Addendum to an application for ‘Erection of new boundary treatment; resurfacing of the forecourt; installation of nursery play equipment; freestanding sign; changes to front elevation door. (There is an associated advertisement application: HGY/2026/1188).’ (reference HGY/2026/1143) at Old Station House, 7A Coppetts Road, Hornsey, London, N10 1NN

This Addendum has been prepared by WEA Planning as the agent on behalf of the applicant to respond to the consultation responses for the proposed development “Erection of new boundary treatment; resurfacing of the forecourt; installation of nursery play equipment; freestanding sign; changes to front elevation door. (There is an associated advertisement application: HGY/2026/1188).’ at 7A Coppetts Road (ref: HGY/2026/1143). The key concerns raised include the use of the premises as a nursery, potential transport impacts, air quality, neighbouring amenity, design and heritage impacts. These are addressed in turn below.

Fig. 1 – Google Street View 2018

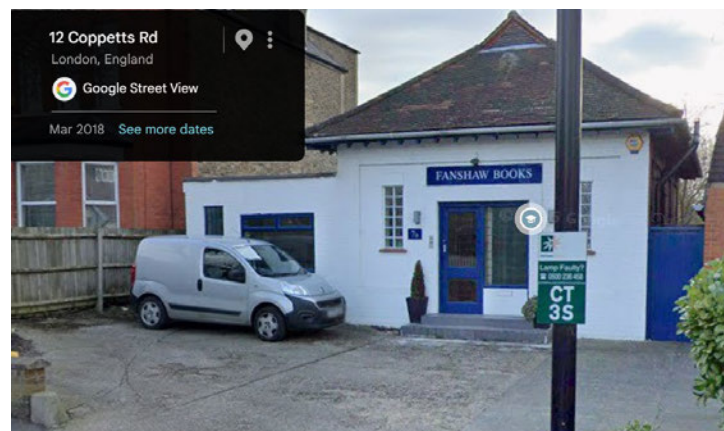
We do not disagree with the LPA's view that the 1991 permission does not restrict the use as a Class E unit. Google Street View images and business profiles from the last 10 years show the unit to have previously been in used for retail premises (fig. 1) for Fanshaw Books and Denes Natural Pet Care store.

Site as used by Fanshaw Books with associated commercial signage and concrete underneath the later addition shingle driveway.

Some comments suggest that signage would be out of keeping with the area, but Google Street view (fig. 1) shows that a previous occupier of the unit had signage at the premises. The wider area consists of a number of commercial, educational and religious buildings with signage. The proposed signage would not be out of character.
